Description of Changes

Item	Control (SM9GV -> OTR_PF1_23)
Before	
After

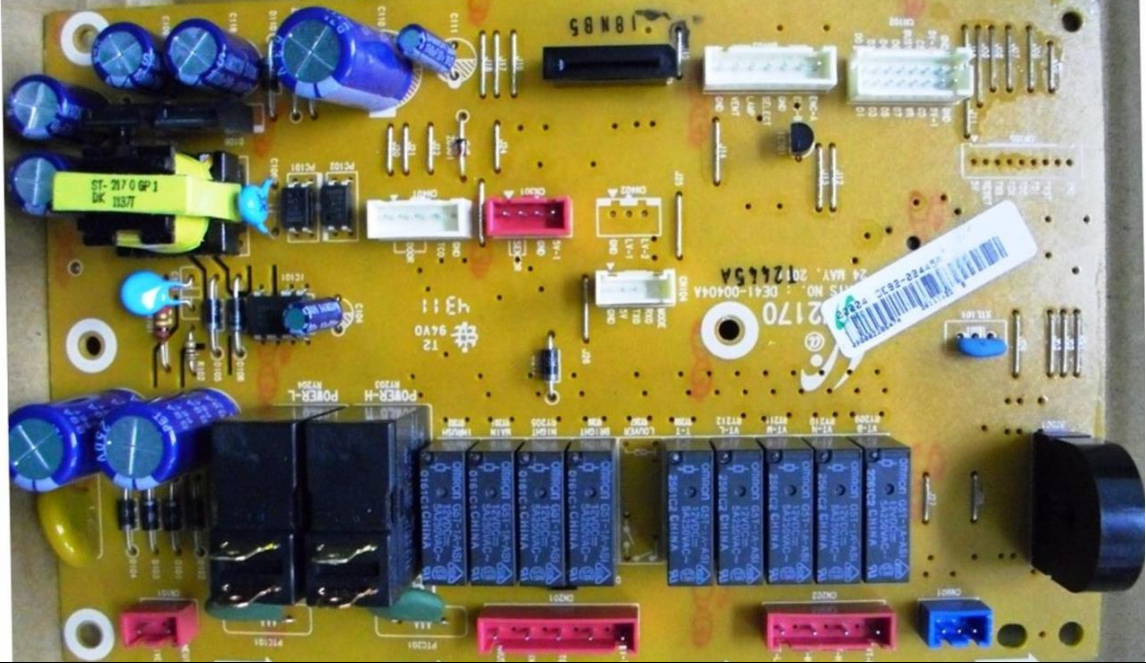
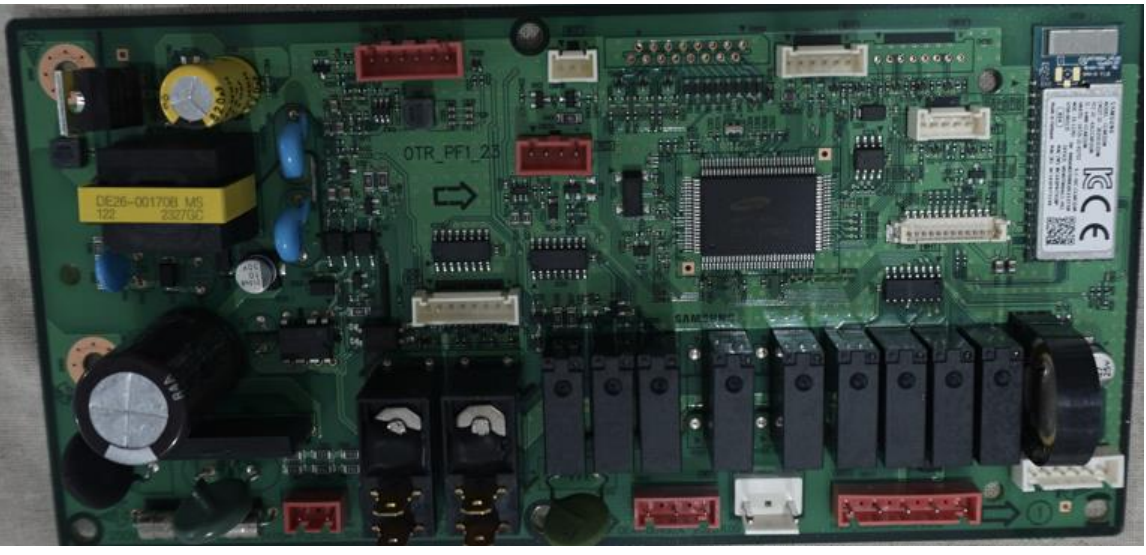
1. There is change of control board
 - 1) Add wireless module by FCC certified
 - 2) New control board (Non-transmitter portion)
 - Overcurrent protection design (Fuse+add NCT)
 - Temperature protection design (add OTP circuit)
